Access Compliance Report Public Rights-of-Way (Curb Ramps)

Main Street: GREENVALE Cross Street: WOODSONG Location: N

ADA ID: RPAT220208115322 Ramp Type: Type 1 - Perpendicular Diagonal Initial Pass/Fail: Fail Overall Compliance: No Severity Score: 4

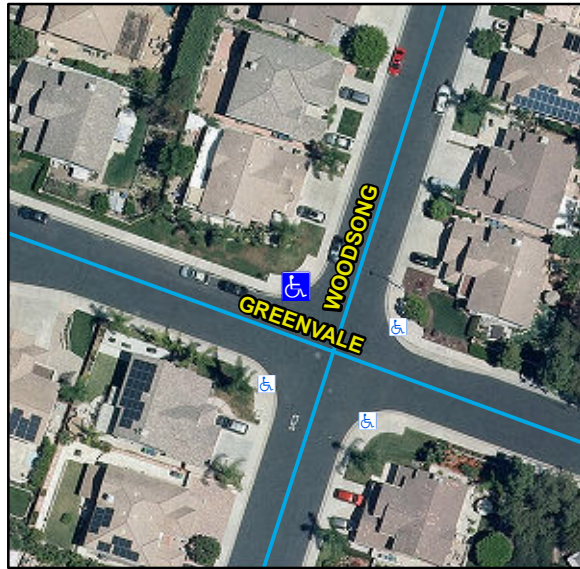
Compliance	Description	Data	Compliance	Description	Data
N/A	Ramp Length (in)	82	N/A	Flare Type LT	
No	Ramp Width (in)	46			N/A
Yes	Ramp Run Slope (%)	6.98	N/A	Flare Slope LT (%)	N/A
Yes	Ramp Cross Slope (%)	3.7	N/A	Flare Traversable LT	N/A
N/A	Landing Present	N/A	N/A	Flare Type RT	
N/A	Landing Length (in)	N/A			N/A
N/A	Landing Width (in)	N/A	N/A	Flare Slope RT (%)	N/A
N/A	Landing Run Slope (%)	N/A	N/A	Flare Traversable RT	N/A
N/A	Landing Cross Slope (%)	N/A	N/A	DWS Provided	N/A
N/A	Landing Movement Obstructed?	N/A	N/A	DWS Contrast	N/A
	Landing Movement Type	N/A	N/A	DWS Length (in)	N/A
N/A	Landing Shared	N/A	N/A	DWS Full Width	N/A
N/A	Clear Space	Yes	N/A	DWS Offset Left (in)	N/A
N/A	Clear Space To Crosswalk (in)	N/A	N/A	DWS Offset Right (in)	N/A
N/A	Marked Crosswalk 1	No	N/A	Marked Crosswalk 2	No
	Crossing 1 Direction	SW		Crossing 2 Direction	SE
	Marked Crosswalk 1 Width (in)	N/A		Marked Crosswalk 2 Width (in)	N/A

Remove & Replace Curb Ramp With Two New Directional Ramps or Equivalent.
